FIELD CHANGE ORDER

This FCO incorporates:
ECO RK05-00061, Air Handling
ECO RK05-00055, Capacitor Bracket

ECO G180-00008, Head Select
ECO G180-00009, Data Reliability

FCO RK05 S 0064 PAGE 1 of 81
Level of Urgency (LOU)

FIGURE #3

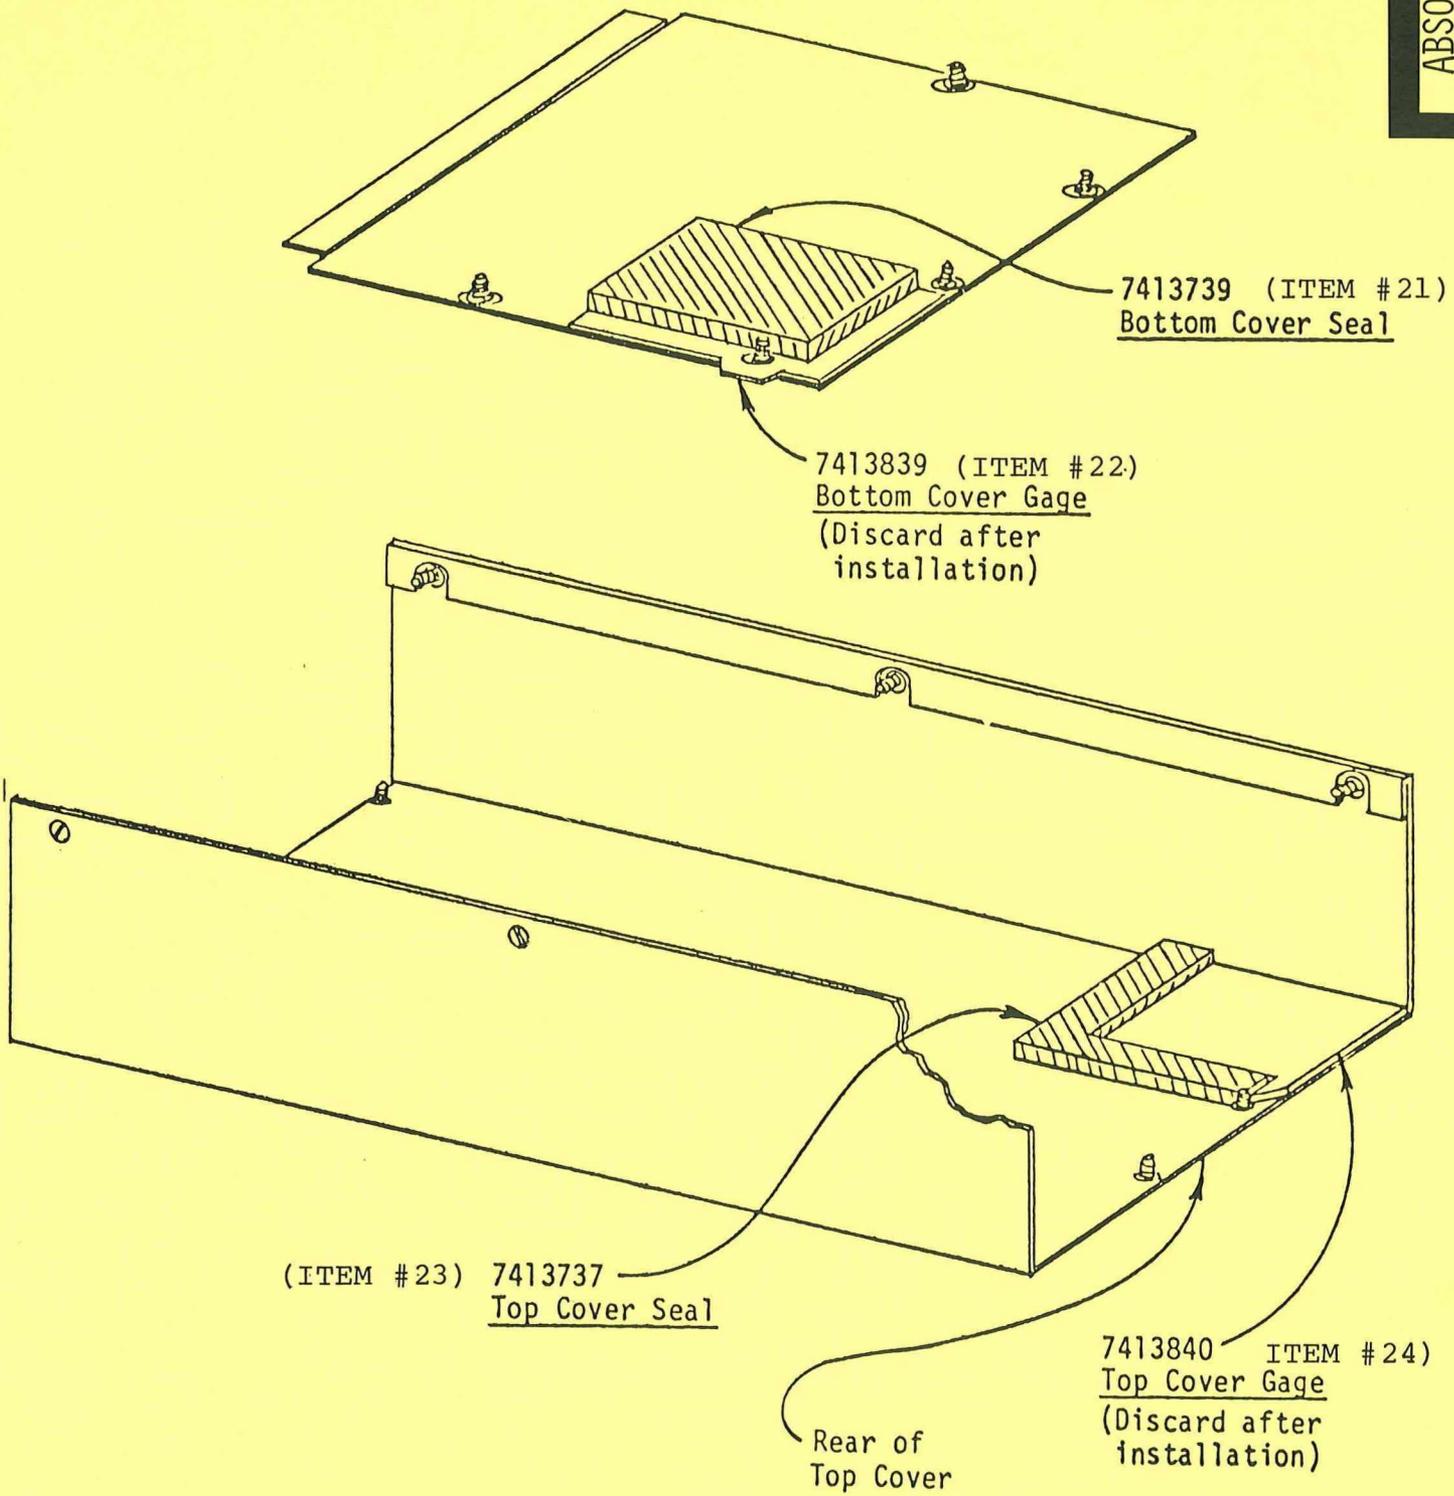
- () 1. REMOVE TOP AND BOTTOM COVERS ON DISC.
- () 2. (FIG #3) USING GAGE (#24) AS INDICATED, REMOVE PROTECTIVE TAPE AND INSTALL SEAL (#23). IF PROPERLY ATTACHED, SEAL WILL CONTACT SIDES OF THE LOGIC BOX (FIG #8), WHEN COVER IS INSTALLED
- () 3. (FIG #3) PLACE BOTTOM COVER GAGE (ITEM #22) ON CORNER OF REAR BOTTOM COVER AS SHOWN. THE HOLE IN GAGE FITS OVER SCREW TO PROPERLY PLACE GAGE. ATTACH SEAL (#21) TO BOTTOM COVER USING GAGE AS GUIDE. THIS SEAL WILL HOLD PRINTED CIRCUIT MODULES FIRMLY IN PLACE WHEN COVER IS INSTALLED.
- () 4. (FIG #4) INSTALL "L" SHAPED JOINT SEAL (#25) IN CORNER OF LOGIC BOX AS INDICATED. FIRST REMOVE THE M7100, M7101 AND M7102 MODULES AND LAY ASIDE, NOTICE PLACEMENT ORDER AND DIRECTION COMPONENT SIDES ARE FACING. IF G180 IS REMOVED, MARK TOP HEAD WIRE PLUG WITH FELT PEN.

NOTE: Position accurately the first time. Almost impossible to reposition in one piece.

FIGURE #4

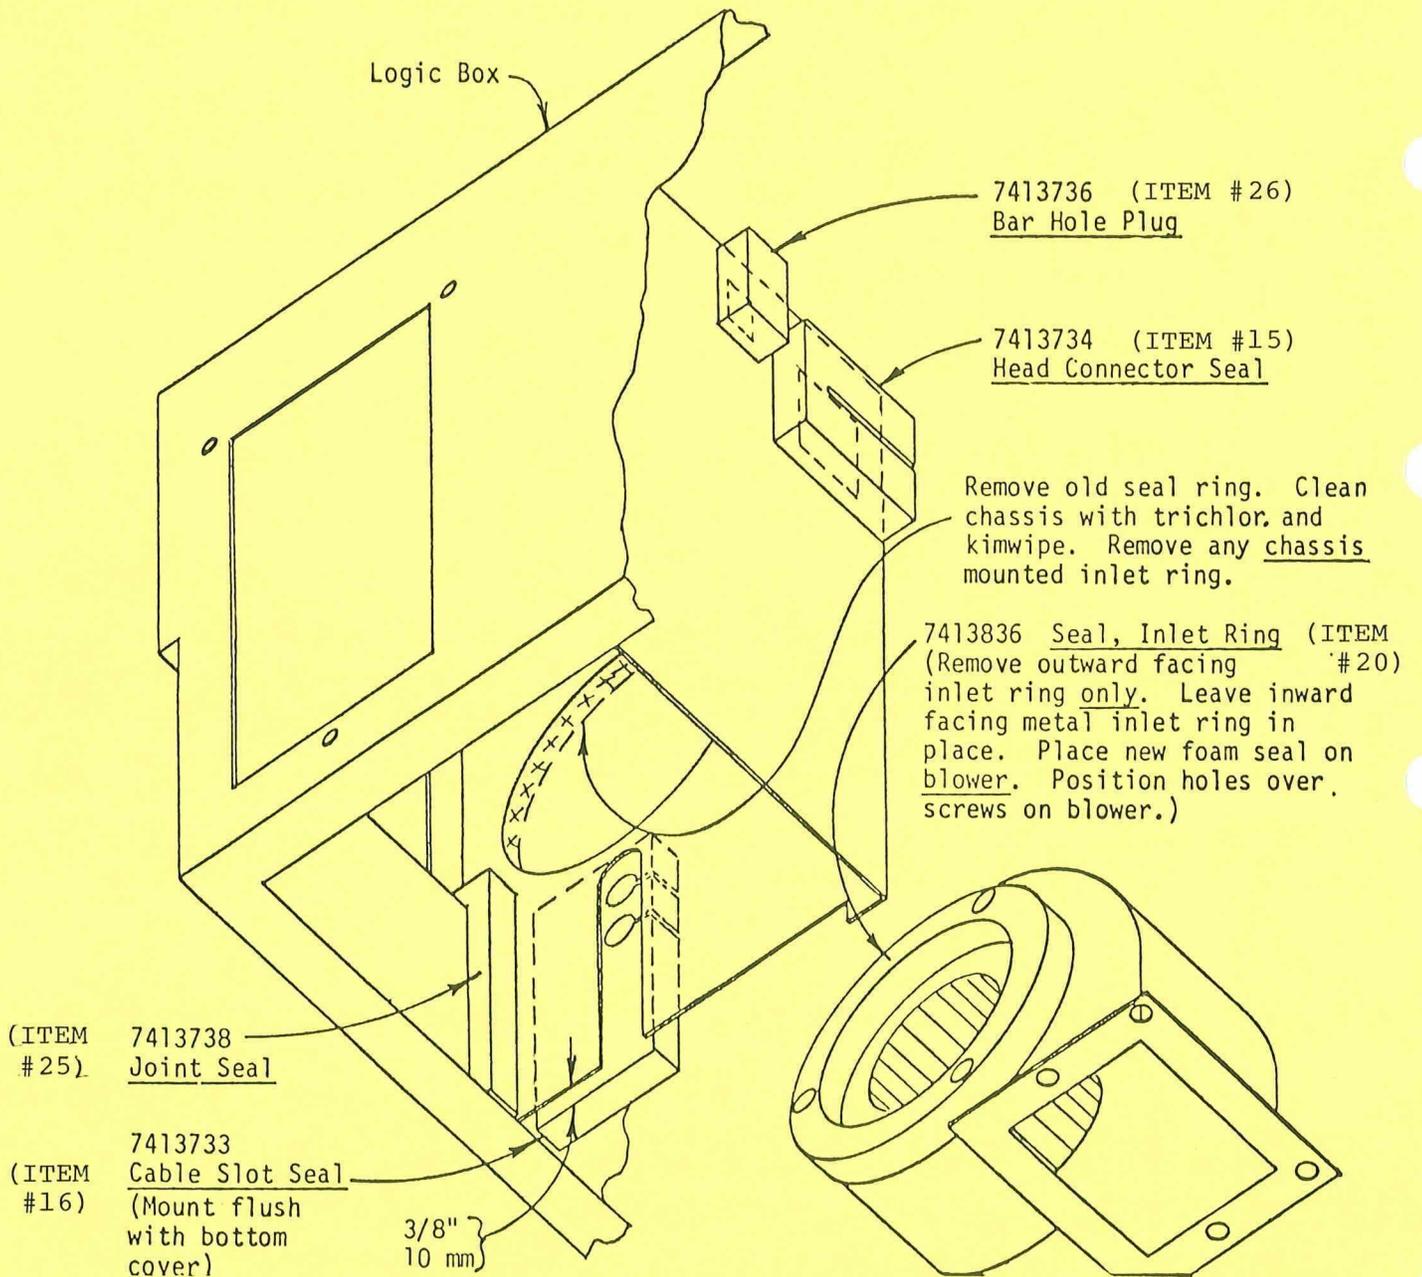
- () 5. (FIG #4) NEXT INSTALL ITEM #26 AND #15 OVER HOLES IN LOGIC BOX AS SHOWN. THE LARGER SEAL WITH SLIT WILL GO OVER HEAD WIRES.

- () 2. (FIG #4) INSTALL INLET RING SEAL (#20) ON BLOWER, POSITIONING HOLES IN FORM OVER SCREWS ON BLOWER. CLEAN CHASIS OF ANY FOREIGN MATERIAL BUT BE CAREFUL NOT TO DROP ANY IN FILTER INTAKE HOLE.

- () 3. (FIG #4) INSTALL CABLE SLOT SEAL (#16) ON LOGIC BOX OVER TWO WIRES. BEFORE PLACING SEAL ON BOX POSITION SO THAT 3/8" IS OVERHANGING ON THE BOTTOM.

Remove and Discard

- (1) Plenum Cover
- (1) Filter with foam gasket
- (1) Air duct, Rev. C
- (4) Old blower hold-down screws
- (4) Blower split ring washers
- (4) Old air duct hold down screws

FIGURE #5

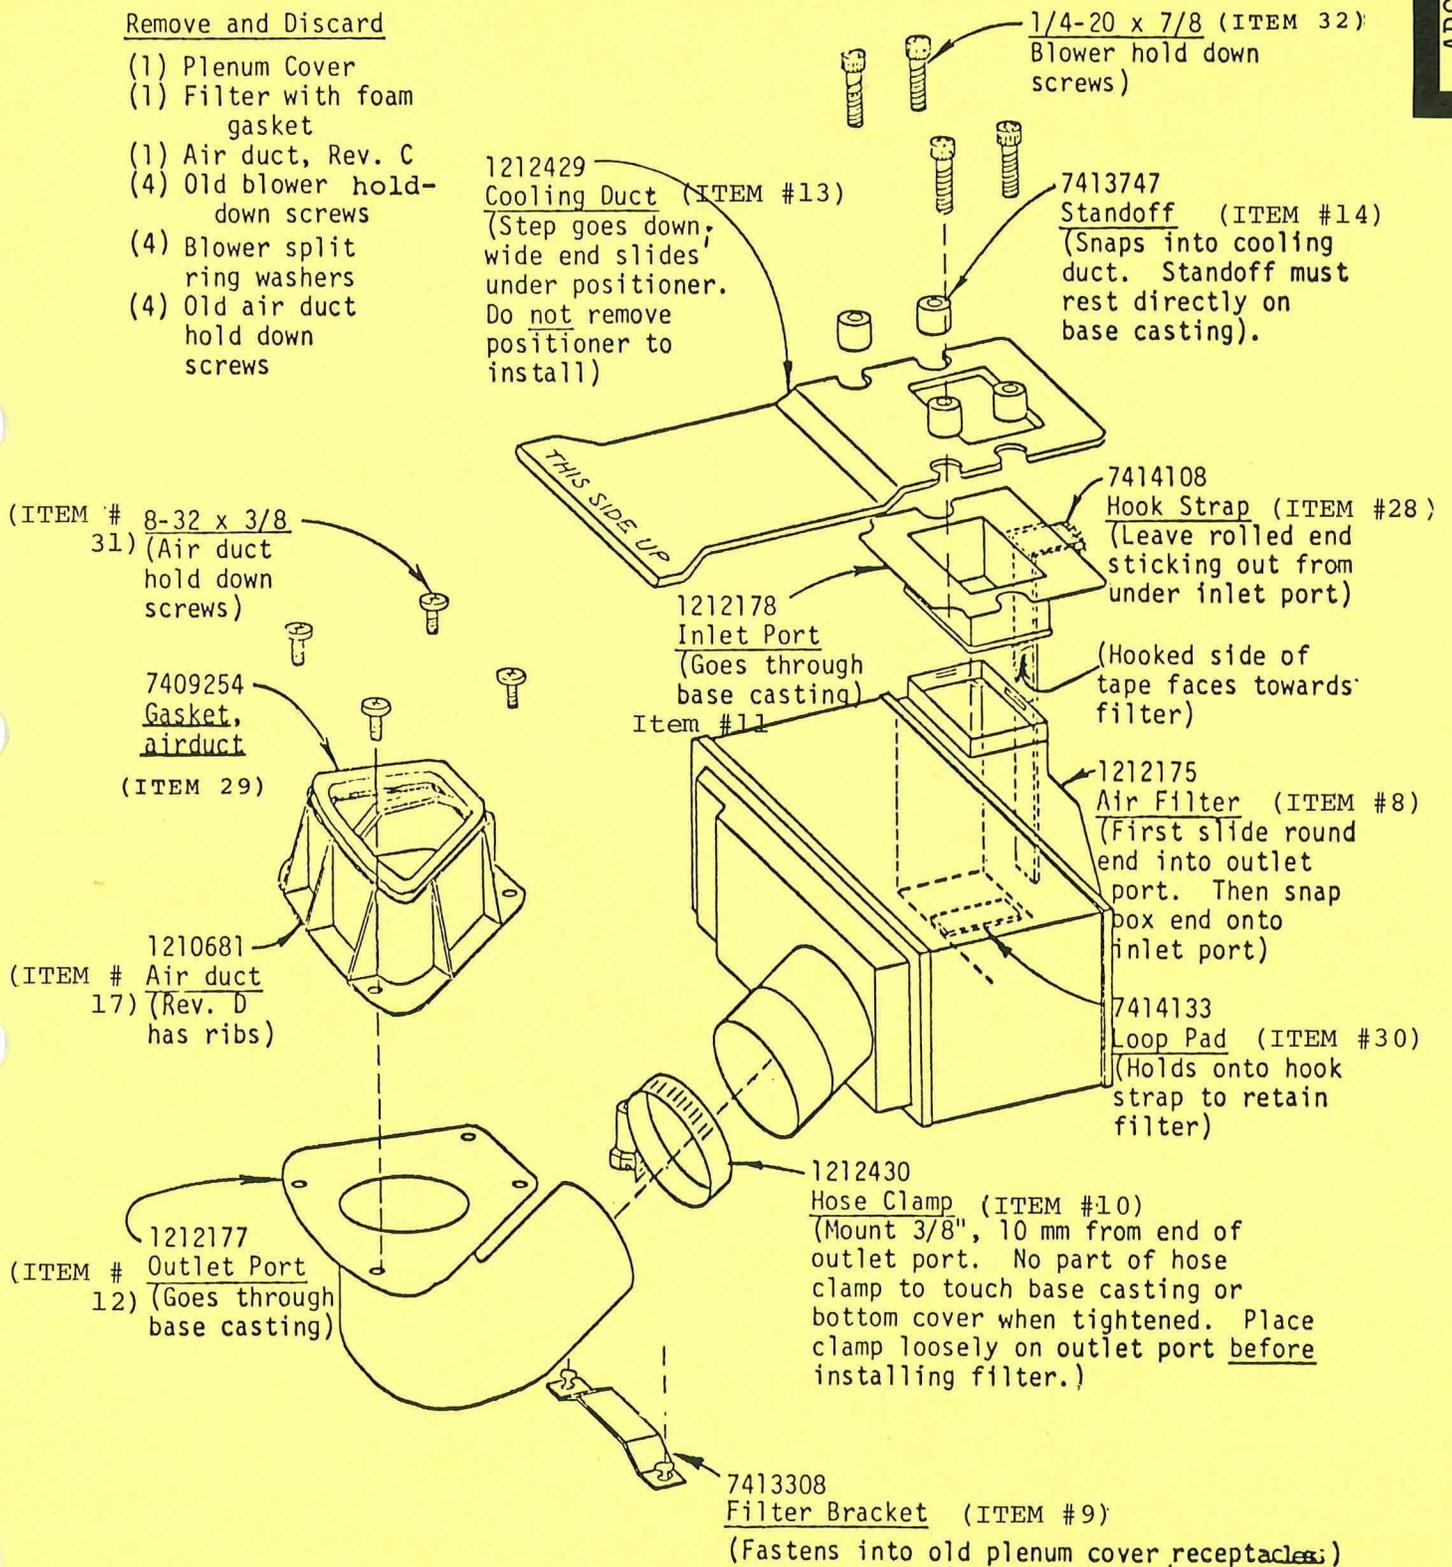
- () 5. (FIG #5) INSTALL INLET PORT (#11) THROUGH HOLE IN CASTING UNDER BLOWER ASSEMBLY, BE SURE TO INSERT HOOK STRAP (#28) SO THAT ROLLED END IS STICKING OUT FROM UNDER INLET PORT. ALSO FACE THE HOOKED SIDE OF THE HOOK STRAP TOWARD THE CENTER OF THE DRIVE. THIS WILL LATER CONNECT TO THE LOOP PAD (#30) TO RETAIN THE NEW FILTER.

- () 6. (FIG #5) SLIDE COOLING DUCT (#13) UNDER POSITIONER WITH "THIS SIDE UP" MARKINGS FACING UPWARD. THIS WILL GIVE ADDITIONAL COOLING FOR THE REGULATORS.

- () 7. (FIG#5) INSERT STANDOFFS (#14) INTO HOLES PROVIDED IN THE COOLING DUCT (#13). INSURE THE STANDOFFS REST DIRECTLY ON THE BASE CASTING.
- () 8. (FIG#8) REPLACE BLOWER ASSEMBLY ONTO STANDOFFS AND INSTALL BLOWER HOLD DOWN SCREWS (FIG#5, ITEM 32). BEFORE FINAL TIGHTENING CHECK TO SEE IF HOOK STRAP (#25) IS STILL IN PROPER PLACE STICKING OUT FROM UNDER INLET PORT (#11).
- () 9. (FIG#8) REMOVE OLD AIR DUCT (#17), CLEAN OPENING.
- () 10. (FIG#5) INSERT OUTLET PORT (#12) THRU HOLE IN BASE CASTING WHERE AIR DUCT (#17) WAS JUST REMOVED. THE POSITION FOR INSTALLATION CAN BE VIEWED IN FIG #7, ITEM #12.
- () 11. (FIG#8) INSTALL NEW AIR DUCT (#17) AND TIGHTEN SCREWS PROVIDED.
- () 12. (FIG#8) INSTALL GASKET (ITEM#29) ON AIR DUCT.

This bracket may not be included on newly shipped drives.

FIGURE NO. 6 OLD FILTER SYSTEM (BOTTOM VIEW)

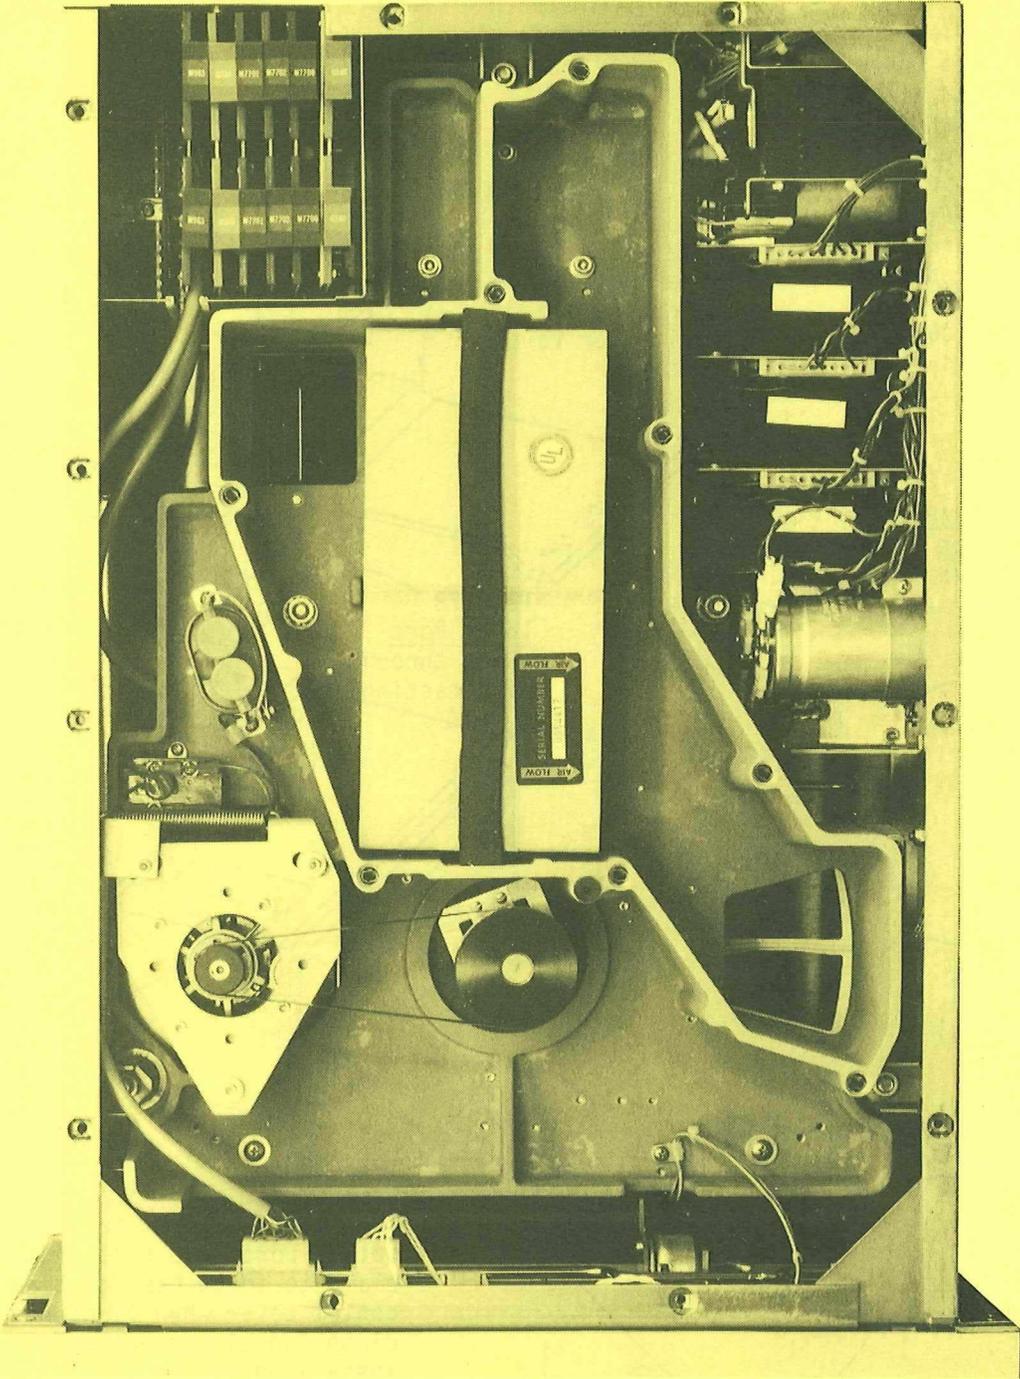
- () 4. (FIG #6) REMOVE PLENUM COVER TO EXPOSE OLD FILTER. AFTER REMOVING OLD FILTER, THE PLENUM COVER CAN BE DISPOSED OF, SINCE IT WILL NOT BE USED WITH THE NEW FILTER.

FIGURE NO. 7 NEW FILTER SYSTEM (BOTTOM VIEW)

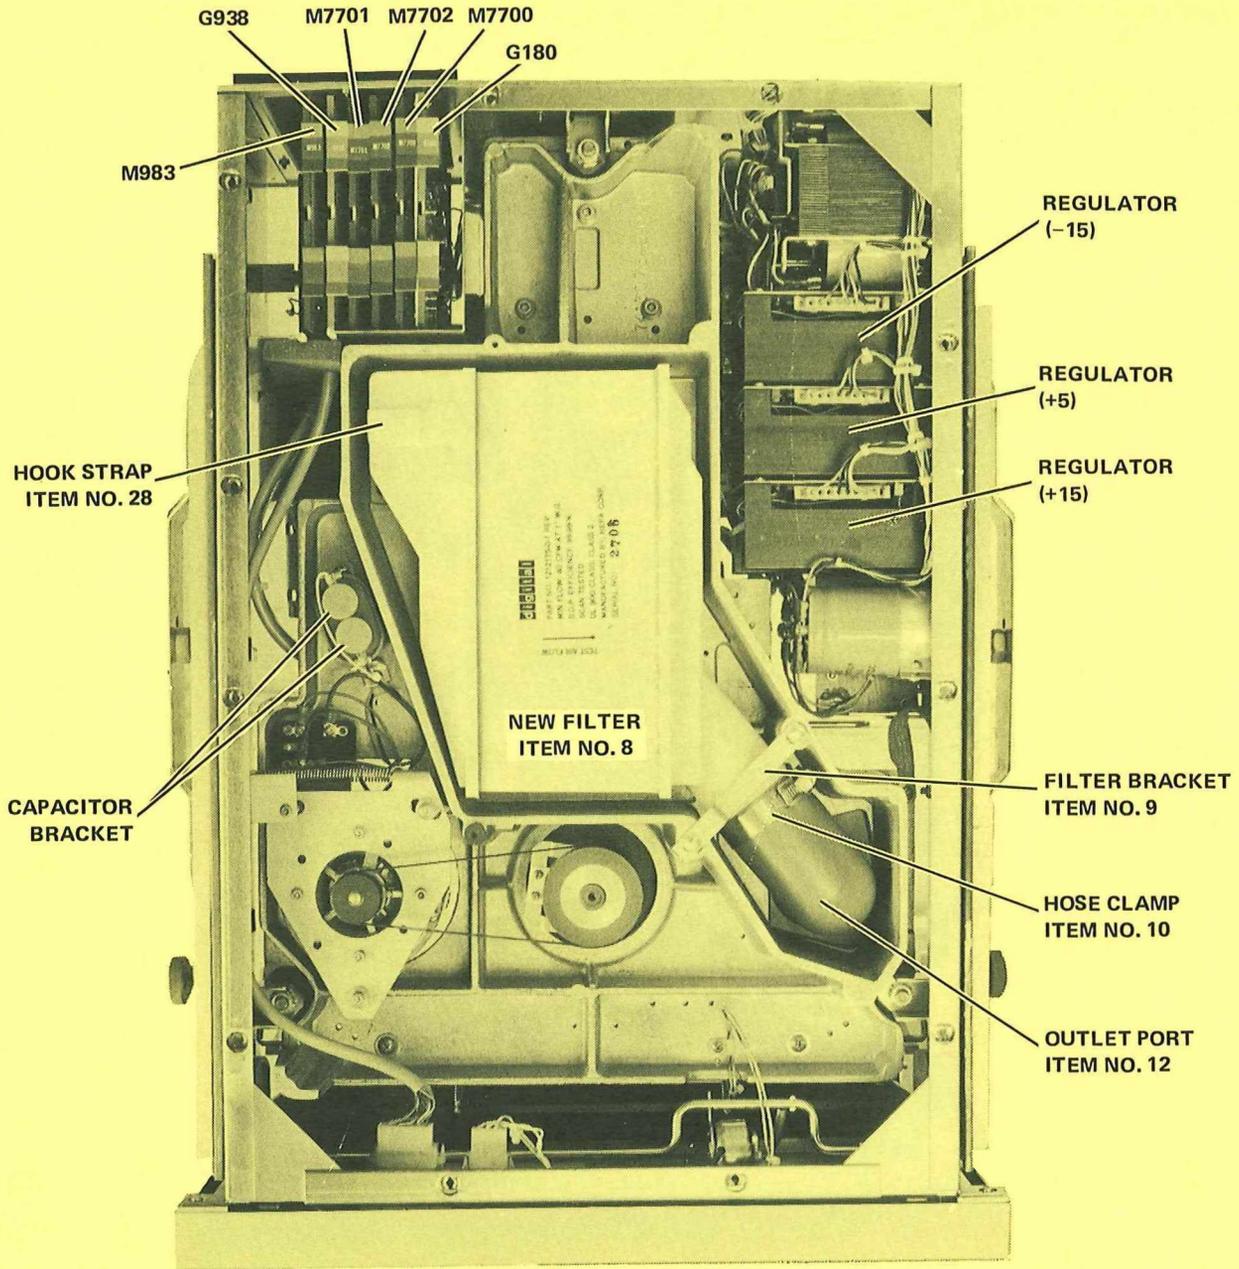
- () 13. (FIG#7) PLACE NEW FILTER IN POSITION IN CAVITY AS VIEWED FROM BOTTOM PHOTOGRAPH. PLACE HOSE CLAMP OVER OUTLET PORT (#12).

- () 14. (FIG#7) INSTALL FILTER BRACKET (#9) AS SHOWN AND TIGHTEN HOSE CLAMP (FIG#10). THE HOSE CLAMP MAY NEED TO BE POSITIONED SO IT WILL NOT RESTRICT THE COVERS WHEN INSTALLED ON THE DRIVE.
- () 15. INSTALL PRINTED CIRCUIT MODULES THAT WERE REMOVED IN STEP #4. USE FIGURE #7 FOR MODULE ORDER KEEPING IN MIND THAT THE COMPONENT SIDE OF THE MODULES WILL FACE TOWARD THE POWER SUPPLY SIDE.
- () 16. MAKE A USUAL CHECK OF CABLES, CONNECTORS AND OTHER PARTS THAT MAY HAVE BEEN MOVED OR LOOSENED DURING INSTALLATION.
